# Site Accessibility Evaluation

## **Frytown Shed**

**1895 Angle Rd SW  
Kalona, IA 52247**

***Inspection Date: 04/24/2019***

**Finding: 2**

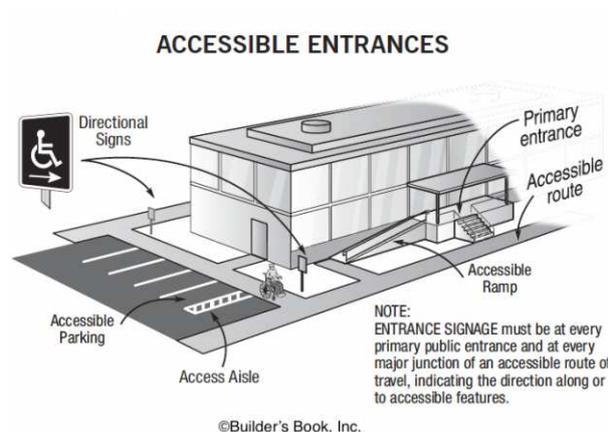
There is no accessible route between the buildings.

At least one accessible route shall connect accessible buildings, facilities, elements and spaces that are on the same site.

Gravel route

Create AR with crushed and compacted stone or similar outdoor material from building to building within the site

## Finding: 5

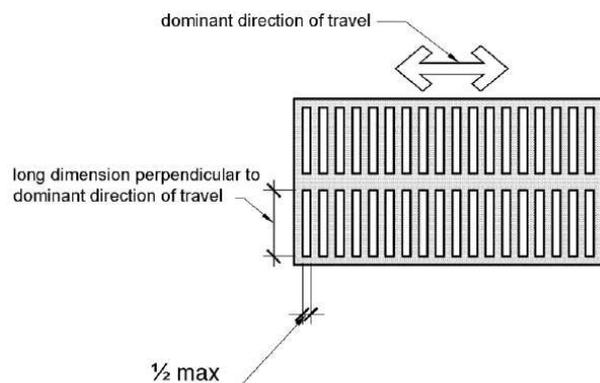
Gratings are spaced greater than a 1/2 inches in the direction of traffic flow.

Openings in floor or ground surfaces shall not allow passage of a sphere more than 1/2 inch diameter. Elongated openings shall be placed so that the long dimension is perpendicular to the dominant direction of travel.

1" grates in bays

Replace grate with one having max openings of 1/2 inch.

### Finding: 6

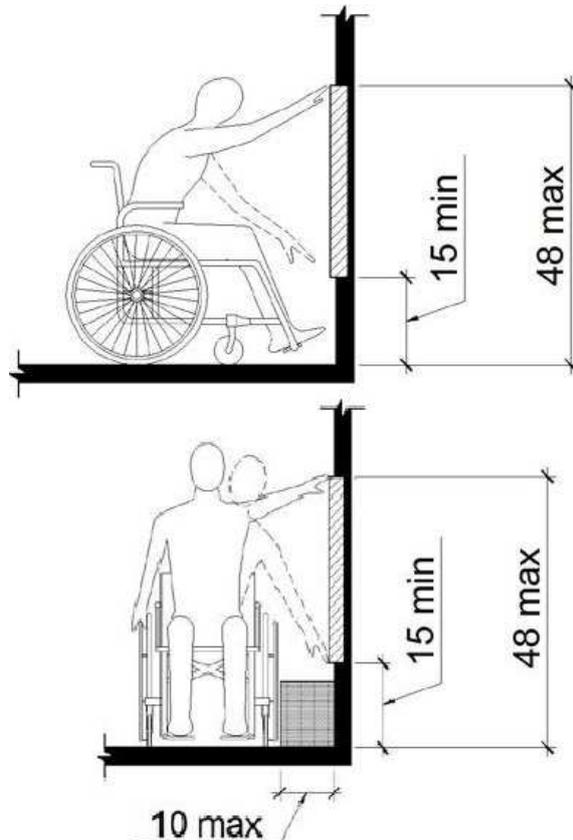
The door control is positioned too high for either a side or front approach.

Where a clear floor or ground space allows a parallel approach to an element and the side reach is unobstructed, the high side reach shall be 48 inches maximum and the low side reach shall be 15 inches minimum above the finish floor or ground.

overhead door  
controls high in bays

For deficit, leave as is, employee work area pursuant to 2010 Standards 106.5 Defined Terms, until an employee with a disability works here

### Finding: 8

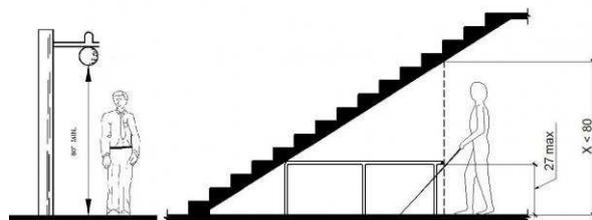
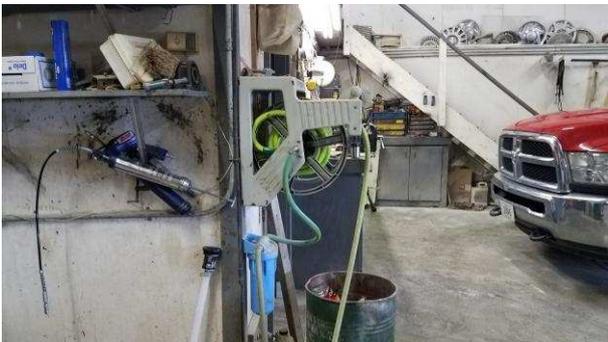
The hose reel and shelves project more than 4 inches into the circulation path.

Wall-mounted objects that have leading edges between 27 inches and 80 inches from the floor must not project more than 4 inches into the circulation path. Protruding objects that extend to the floor or within 27 inches of the floor are cane detectable and are therefore not hazardous. Where it is necessary or desirable to have objects protrude from the wall, a manner of cane detection must be provided.

hose reel and shelves  
protrude in bays

For deficit, leave as is, employee work area pursuant to 2010 Standards 106.5 Defined Terms, until an employee with a disability works here

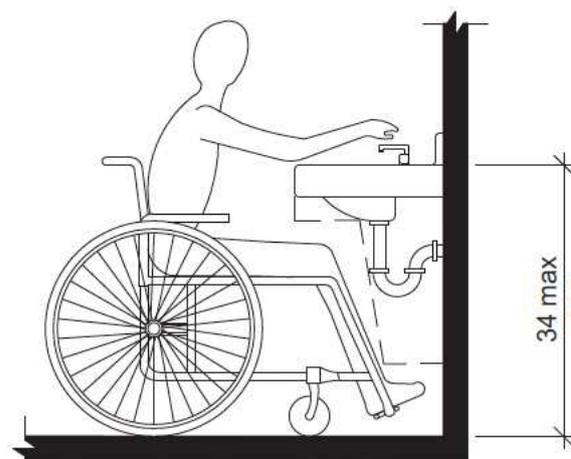
The sink is not accessible.

A clear floor space at least 30 inches by 48 shall be provided in front of a sink to allow forward approach.

sink in break room  
36" with cabinets

Lower sinks to max 34" aff to front of rim

Remove cabinets to provide knee and toe clearance

## Finding: 9

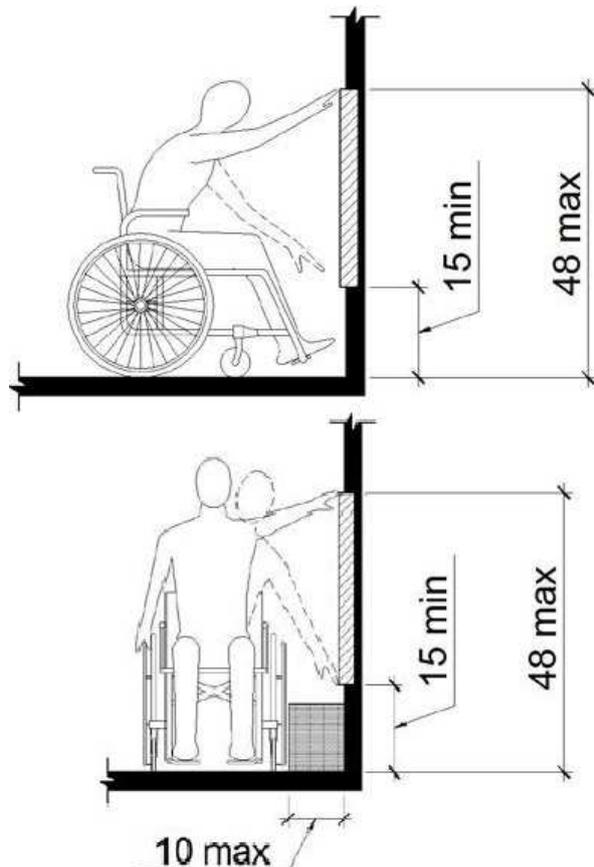
The microwave is positioned too high for either a side or front approach.

Where a clear floor or ground space allows a parallel approach to an element and the side reach is unobstructed, the high side reach shall be 48 inches maximum and the low side reach shall be 15 inches minimum above the finish floor or ground.

59" to microwave in break room

Remount operable parts to be in reach range of 15" min to 48" max

**Finding: 10**

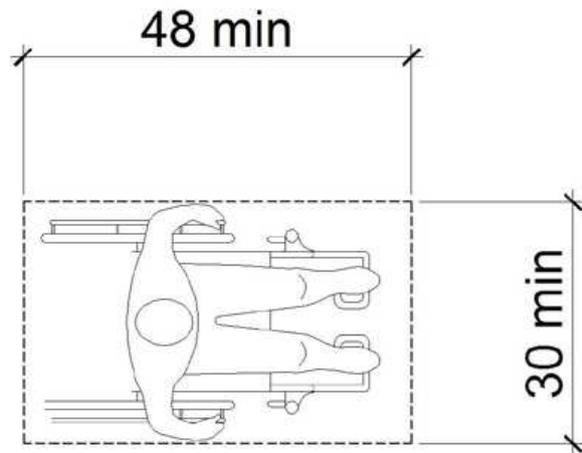
The operable part is not accessible because there is not adequate clear floor space for either a forward or side approach.

The clear floor or ground space shall be 30 inches minimum by 48 inches minimum.

fridge in break room  
lacks, AC unit lacks

Remove, or relocate storage in CFS at fixtures and operable parts along the AR

### Finding: 13

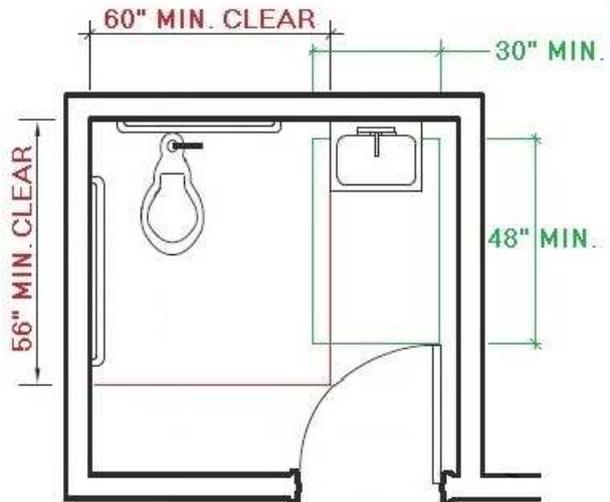
The restroom is not nearly compliant.

The restroom does not have the required minimum clear floor space or maneuvering clearances for the toilet, The restroom does not have the required minimum clear floor space or maneuvering clearances for the lavatory, The entry door does not contain the required minimum maneuvering spaces on the pull/push sides, The entry door encroach into the required clear floor space for fixtures, Grab bars are missing and/or incorrectly installed, Accessories, such as toilet seat covers, paper towel holders, garbage cans, hand dryers, and mirrors are either too high or without clear floor space or both, The restroom contain floor level changes greater than a 1/2 inch of the floor drains and is slope (XX) - (XX), the shower is too small and missing numerous accessible elements.

restroom lacks  
accessible features

Create a compliant wheelchair accessible restroom and correct all features to be accessible
